Wisconsin Department of Transportation

Proposal #13: 1166-06-75, WISC 2021482
Plainfield – Stevens Point
USH 10 B-49-0024
IH 39
Portage County

This is Addendum No. 01, which provides for the following:

SDD 14B32-a Concrete Barrier Single Slope (CBSS)

**Addendum No. 01
ID 1166-06-75
Added Sheet 508A
August 25, 2021**

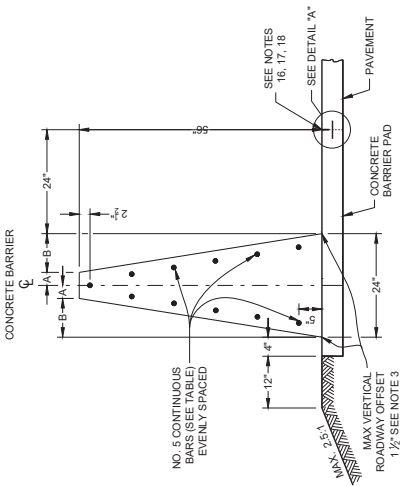
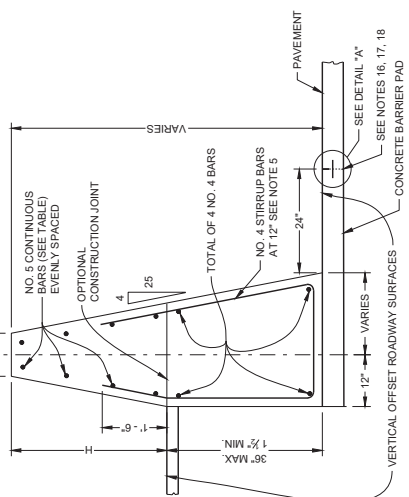
ADDENDUM to this SDD 8/4/2021: DELETE GENERAL NOTES 13 AND 14
